Campaign No. 2021050004, May, 2021

SUBJECT: **Model 907 Sprinter, Model Year 2019**
Update Incorrect VIN

D60.00-A055-79

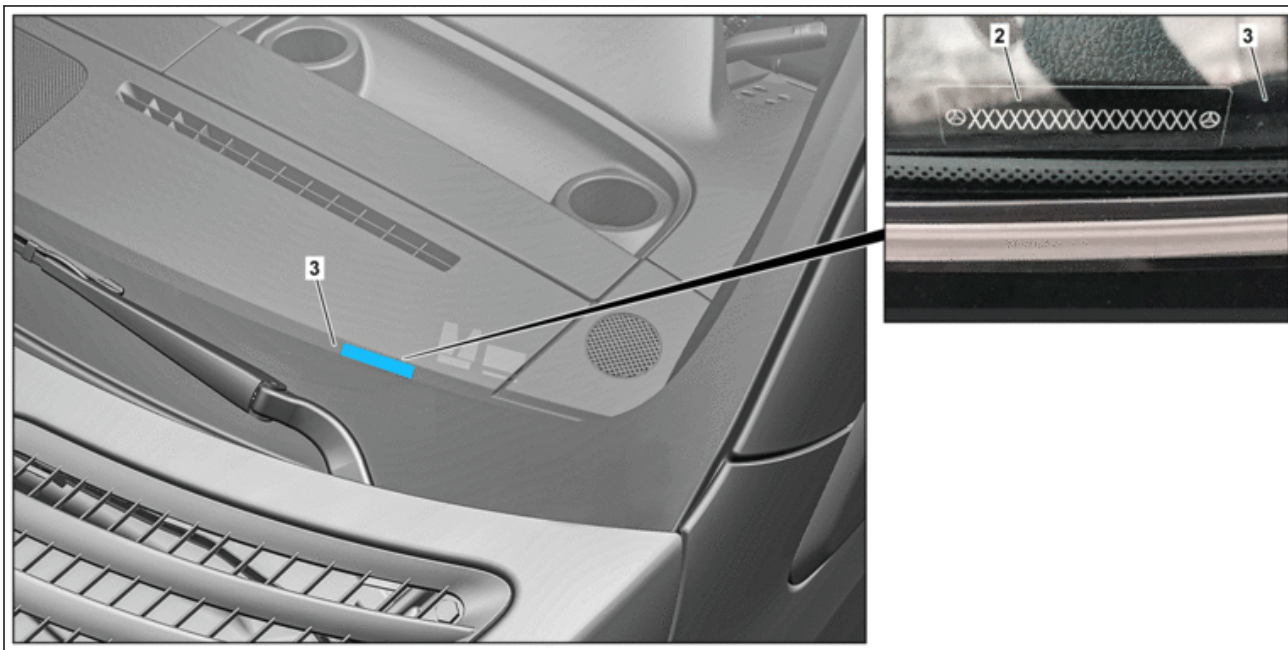
3	Replace information label (2).	 Bonding surface must be absolutely dry and free of dust and grease. This prevents any adhesion problems.  Incorrect vehicle identification number: WDZPF0ED6KT016360 Correct vehicle identification number: W1Z40FHYXKT016360  Aid of helper required. Cleaner	BR00.45-Z-1025-04A

D60.00-A056-79

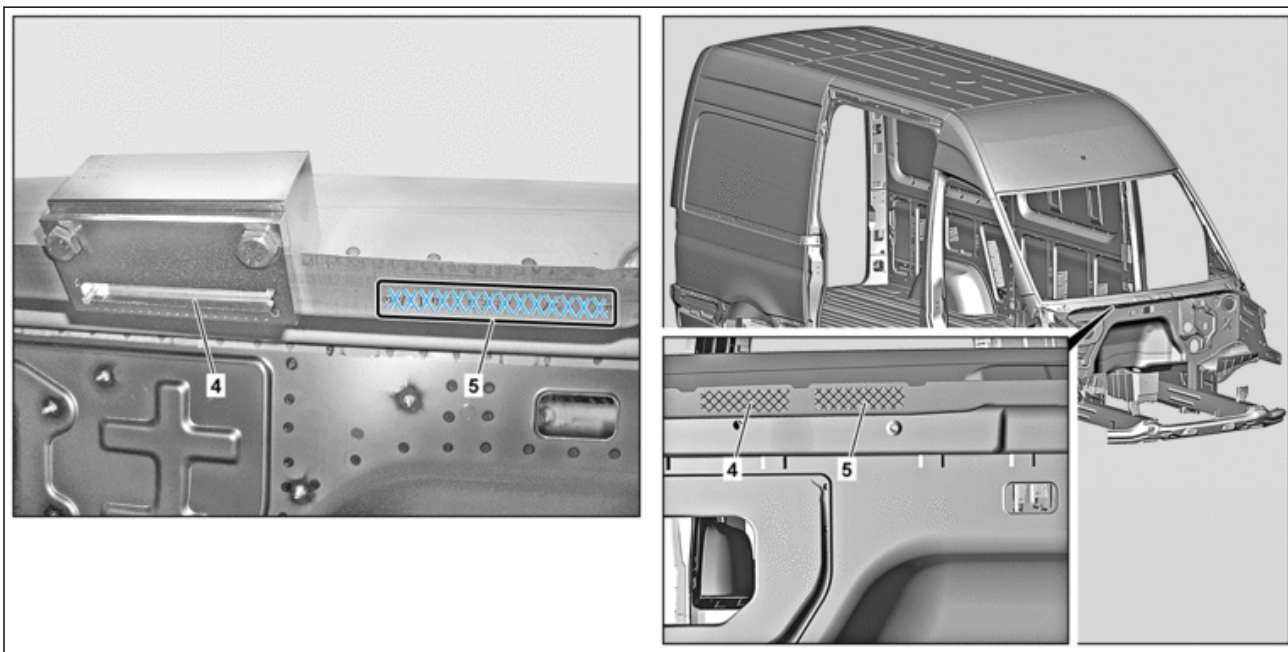
Remove		
4 	Remove ventilation box.		AR83.10-D-0010TS
5	Remove engine compartment seal in area of reserve field (4).		
	Punch in VIN		
6 	Stamp correct vehicle identification number into reserve field (4).	 Cross out incorrect vehicle identification number in standard field (5).  Incorrect vehicle identification number: WDZPF0ED6KT016360 Correct vehicle identification number: W1Z40FHYXKT016360  Stamping guide  Star marking punch  Letter marking punch  Letter marking punch  Die stamp numbers	AR60.00-D-0800TS 906 589 10 63 00 000 589 02 39 00 000 589 00 39 00 000 589 03 39 00 000 589 01 39 00
 Danger	Risk of explosion caused by paint vapors igniting. Risk of poisoning caused by inhaling paint vapors.	No smoking! No open fire! Use respiratory protection, protective clothing, gloves, safety glasses and protective skin cream. Ensure that the area is well ventilated.	AS98.00-Z-0002-01A
7	Paint repair area and adjacent surfaces using a brush or spray can.
